AGENDA
HISTORIC DISTRICT COUNCIL
REGULAR MEETING
SEPTEMBER 19, 2024
5:00 PM
CITY HALL COMMISSION CHAMBERS
204 ASH STREET
FERNANDINA BEACH, FL 32034

HISTORIC DISTRICT COUNCIL STAFF REPORT
HDC 2024-0020
SEPTEMBER 19, 2024

2
A301
EXTERIOR ELEVATION
SOUTH EXTERIOR ELEVATION
1/4" = 1'-0"

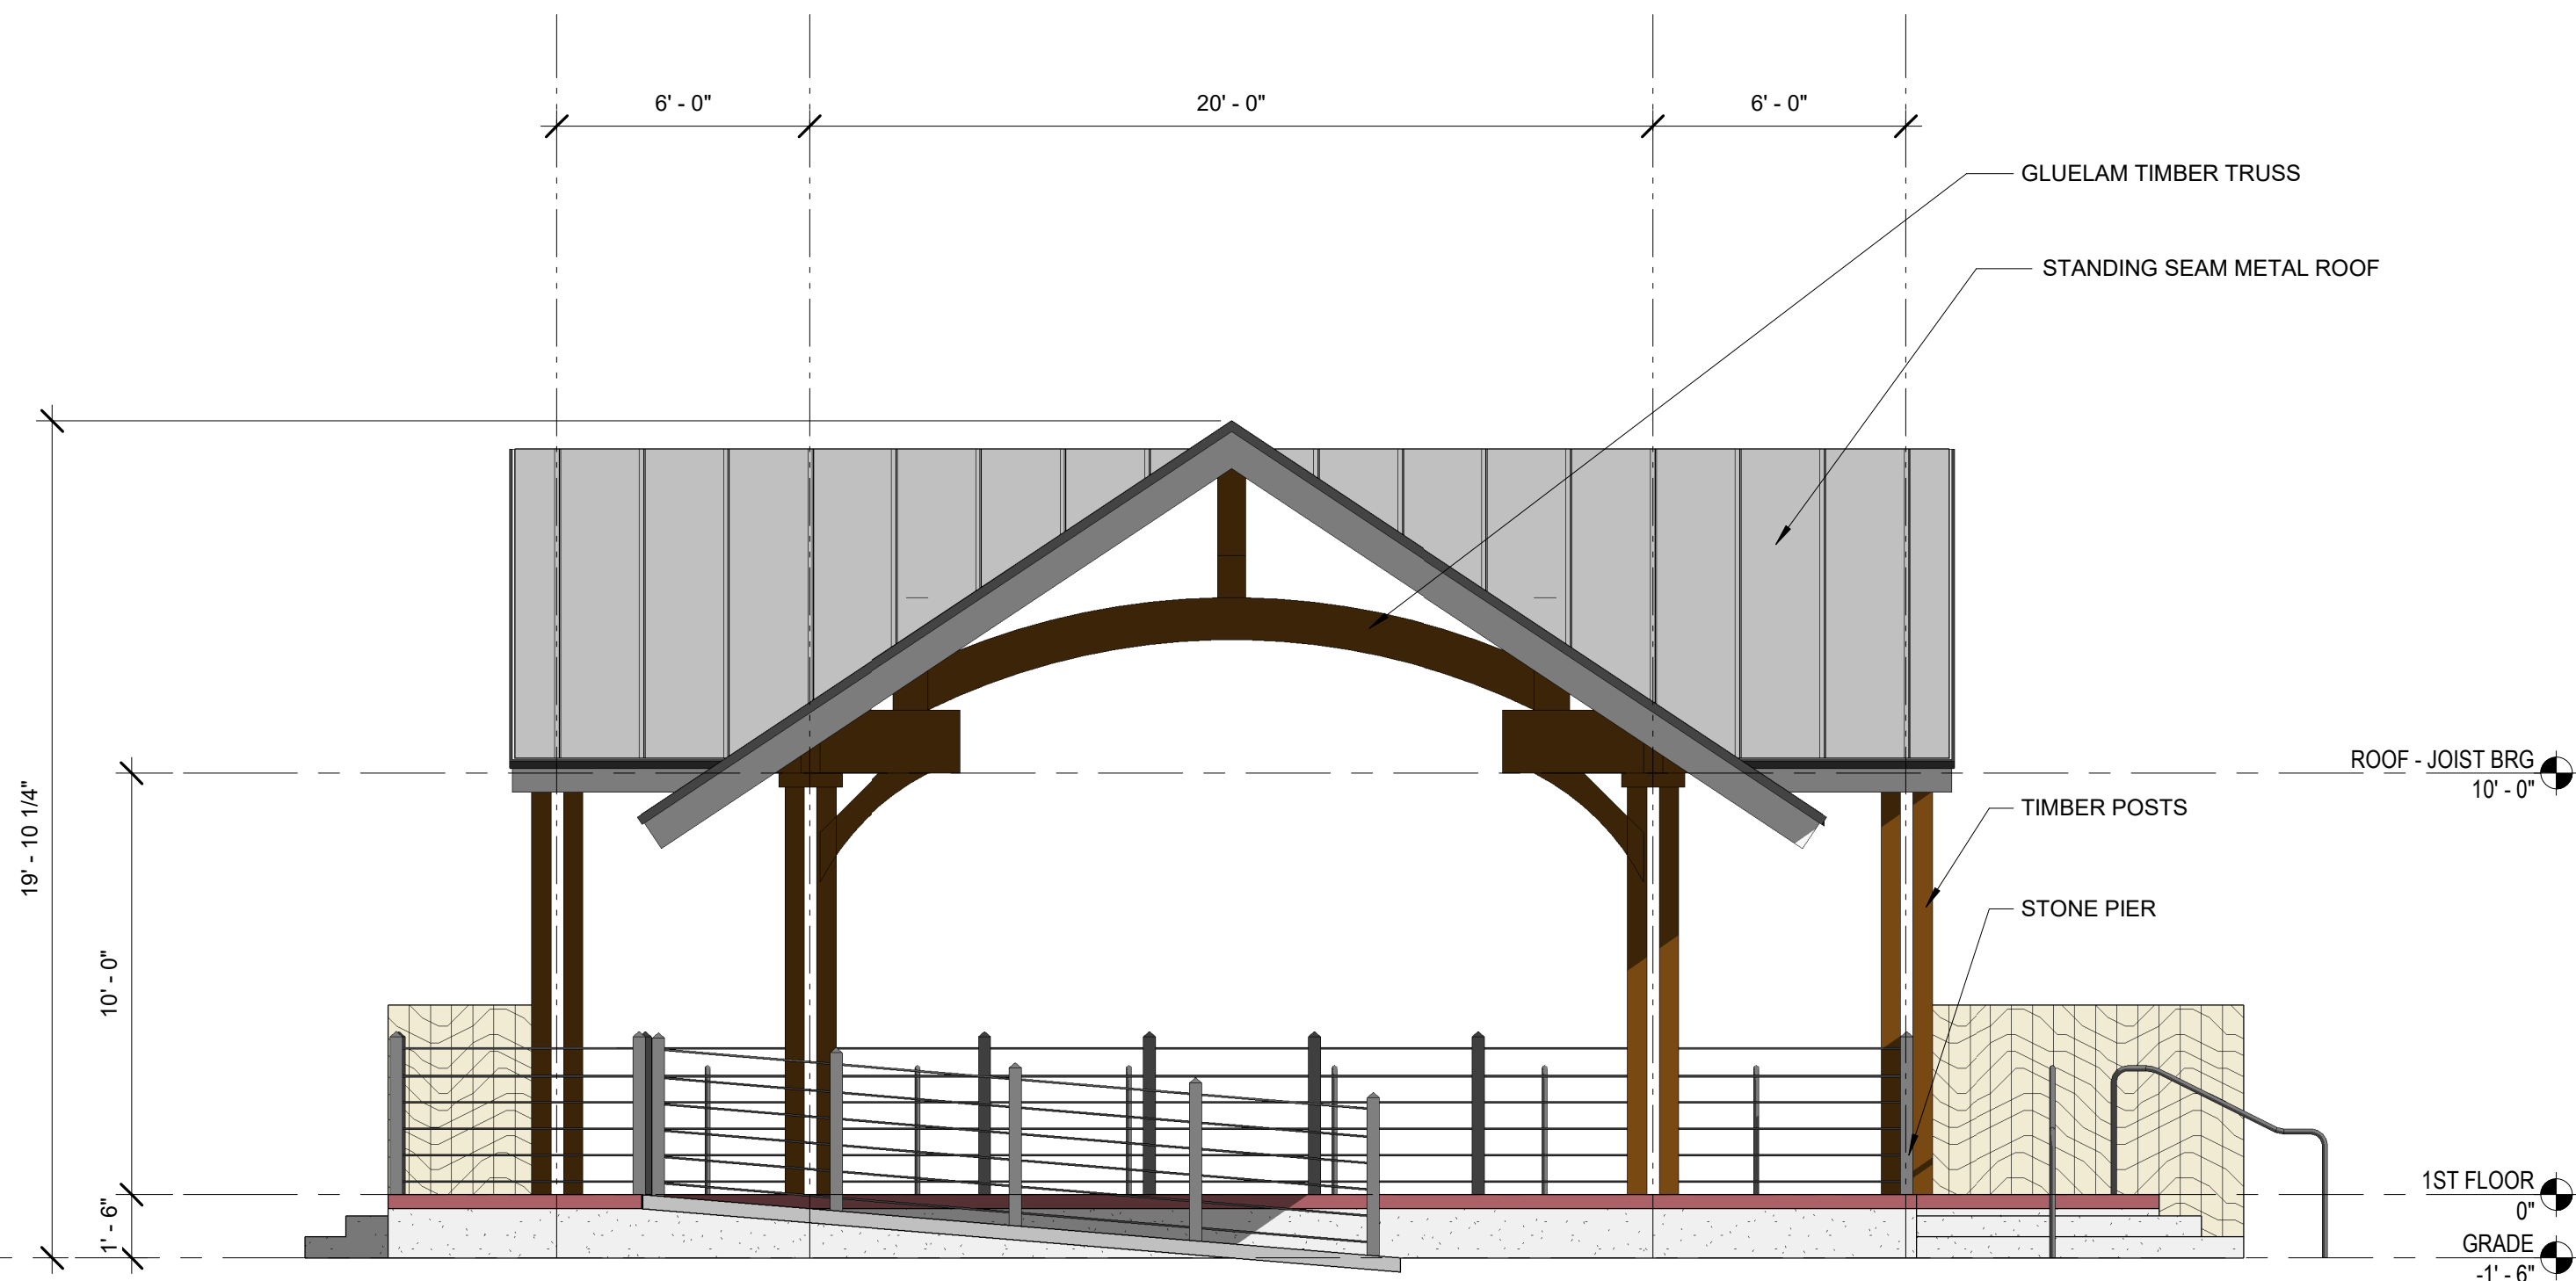
Lisa Finkelstein, Chair of the CRA Advisory Board, addressed the concerns of the Board at the June 27, 2024, previous meeting. She noted the removal of the concrete planters, the spoke of the height concerns, the ramp, the

bracketing style, the railing cabling, the wood stamped concrete, the flooring materials, and a larger landscape plan.

The Board discussed these proposed modifications further and suggested simplifying the design, which in turn would reduce costs and help better integrate the structures into the existing environment. They also asked to consider that the final pavilion design ties in with the upcoming Atlantic Seafood project design.

The design of the waterfront and these elements have not been provided to the TRC for technical consideration. This is a necessary next step which must be completed before the issuance of any building permits.

DESIGN OBJECTIVE	To create an architecturally iconic pavilion that reflects the Victorian architecture of Fernadina's Historic District (lap siding, steeply pitched roofs) combined with a working waterfront aesthetic (metal roofs, minimal ornamentation, maritime references), consistent with the CRA Design Guidelines.
COMPATIBILITY	These recommendations will make the pavilion & restroom building architecturally compatible.
SITE PLAN	Site plan shows stairs on the west side overlapping the floodwall. Adopt CRAAB pavilion floor plan and site plan
BUILDING HEIGHT	25' from grade.
ROOF	PITCH - 12/12. EAVES - Bottom edge of roof should align around all four sides. OVERHANGS - 18" minimum. STANDING SEAM METAL - Style and color OK. GUTTERS & DOWNSPOUTS (or rain chains) - Add at each corner. Downspouts should go through the deck to ground below. (Match to Train Depot pavilion gutters and downspouts). SKYLIGHTS - Add four skylights to north/south roof near junction of east west dormers, to bring light into the interior.

GABLES	To reduce rain incursion into the pavilion and to make the design compatible with Historic District architecture, infill gable ends with lap siding and triangular openings at top of gables for light and air flow. Infill south gable end with a circular opening in the lap siding. (Circular opening establishes the front of the pavilion and is a metaphorical sunset).
COLUMNS	8x8s, no double columns.
DECK	Remove northwest corner of deck per CRAAB floor plan. Brazilian Ipe wood decking OK. Eliminate brick and make entire deck Ipe.
STAIRS	Concrete Steps and Edge Ribbon OK. Three steps with 7" risers, so deck height is 21". (Since pavilion will be used for stage performances, increased height of the stage and deck is needed).
ADA RAMP	Should be 21' long x 5' wide. Ramp will also be used to move equipment for stage performances, so wider width is necessary.
RAILINGS	Cable OK, with 4x4 posts. Add minimal top rail.
